Re: The Royal Golf Club Residential Development (EAW)

Thank you for submitting a copy of the Environmental Assessment Worksheet (EAW) for the proposed The Royal Golf Club Residential Development. The proposed project is located within the Valley Branch Watershed District (VBWD). I offer the following comments on behalf of the VBWD. The numbers correspond to the numbers in the EAW.

Figure 20
HIGH PRIORITY AREAS
AND GREENWAY CONNECTIVITY
Valley Branch Watershed District, MN

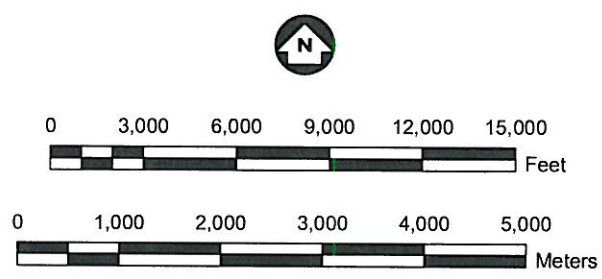
a.ii Plans (Page 6): While the site does not lie within a Minnesota Department of Natural Resources planned conservation corridor, the site is within an existing, somewhat connected, natural greenway corridor, as shown on Figure 20 of VBWD's March 2013 *Results of Minnesota Routine Assessment Method (MNRAM) for Evaluating Wetland Function* (attached).
